PATENT APPLICATION  
Attorney Docket No.: ANAT-1015US2  
(ELL-036)

In re Application of: )  
 )  
Frampton E. ELLIS, III )  
 )  
U.S. Application No.: 09/527,019 )  
 )  
Filed: 03/16/2000 )  
 )  
For: Removable Rounded Midsole )  
Structures and Chambers with )  
Computer Controlled Processor- )  
Controlled Variable Pressure )

**PETITION FOR REVIEW OF DRAWING OBJECTION**

FIG. 11Q

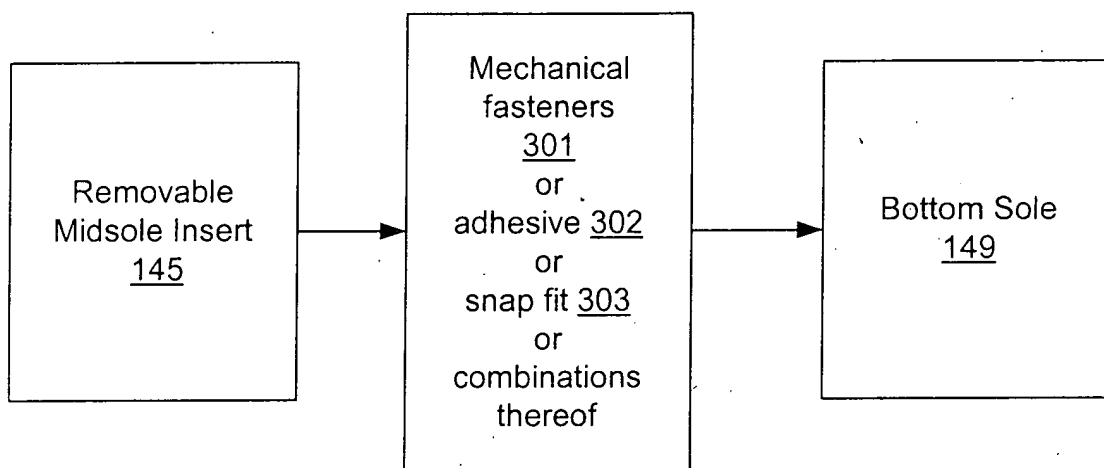
"The drawings are objected to under 37 C.F.R. §1.83(a). The drawings must show every feature of the invention specified in the claims. Therefore, the mechanical fasteners, a snap fit and 'combinations thereof', as stated in claim 4 [sic] and the computer control specifics of claim 14, must be shown or the feature(s) canceled from the claim(s). No new matter should be entered. The drawings submitted on October 5, 2001 have been received. The changes to the existing drawing have been approved but the addition [sic] of drawing 11Q, being [sic] a schematic drawing of the claimed subject matter does not clearly show what applicant is claiming, especially the 'combinations thereof'. Therefore, this drawing will not be entered."

In section 1 of the Final Rejection dated January 2, 2002, the Examiner objected to the drawings under 37 C.F.R. § 1.83(a) asserting that the drawings do not show every feature of the invention as represented in the claims. In particular, the Examiner stated that use of "mechanical fasteners, snap fits, and combinations thereof" is not clearly depicted in the new Figure 11Q - a schematic representation of "mechanical fasteners, snap fits, and combinations thereof" which was submitted by the Applicant on October 5, 2001.<sup>1</sup> On this basis, the Examiner has refused to enter this new Figure 11Q. The Examiner has asserted that new Figure 11Q does not depict what is claimed in Claim 4 [sic].<sup>2</sup>

Second, as clearly stated in the MPEP § 608.02, Examiner Note No. 3, if drawings are disapproved, an explanation must be provided by the Examiner. In his rejection of Figure 11Q, the Examiner has merely stated that the drawing "does not clearly show what the applicant is claiming" without providing any rationale or explanation for such a conclusion. Thus, the Examiner has not met his burden of providing an explanation of why new Figure 11Q has been disapproved. For this additional reason, the drawing objection based on claim 24 should be withdrawn.

First, this drawing objection should be withdrawn on the basis the claim 4 has been canceled without prejudice to resubmission and thus it is not necessary to show the features of canceled claim 4 in the drawings.

Thirdly, there is no dispute that Figure 11Q shows the "mechanical fasteners, a snap fit, interlocking geometries, and combinations thereof" since the Examiner admitted in the Final Rejection dated January 2, 2002, that Figure 11Q is "... a schematic drawing of the claimed subject matter..." See Section 1 of the Final Rejection dated January 2, 2002. Accordingly, Figure 11Q clearly meets the requirement that it shows every feature of the subject matter claimed in claim 24.

Finally, the Applicant respectfully disagrees with the Examiner's conclusion. As per 37 C.F.R. § 1.81(b), "Drawings may include illustrations which facilitate an understanding of the invention." Claim 24 of the present application states: "... wherein said inner shoe is releasably secured to said outer shoe by a releasable securing structure selected from the group consisting of mechanical fasteners, a snap fit, interlocking geometries, and combinations thereof." Figure 11Q uses interconnected block diagrams to clearly illustrate the attachment of the removable midsole insert 145 to the bottom sole 149 via "mechanical fasteners 301, or adhesives 302, or snap fit 303, or combinations thereof". Moreover, lines 12-20 of page 46 of the specification describe how, after the bottom sole 149 is attached, the removable midsole insert 145 may be inserted into the interior cavity of the upper 21 and be releasably secured to the top side of the bottom sole 149 by any suitable method, including mechanical fasteners, adhesives, snap-fit arrangements, reclosable compartments, interlocking geometries, or other similar structures. In consideration of the forgoing facts, Figure 11Q quite clearly depicts what is claimed in Claim 24 and what is described on page 46, lines 12-20, of the specification. Therefore, since new Figure 11Q clearly shows all of the elements claimed in claim 24 and finds basis in the specification as discussed above, the Applicant respectfully requests that Figure 11Q submitted on October 5, 2001, be entered as part of this application and that this objection to the drawings be withdrawn.
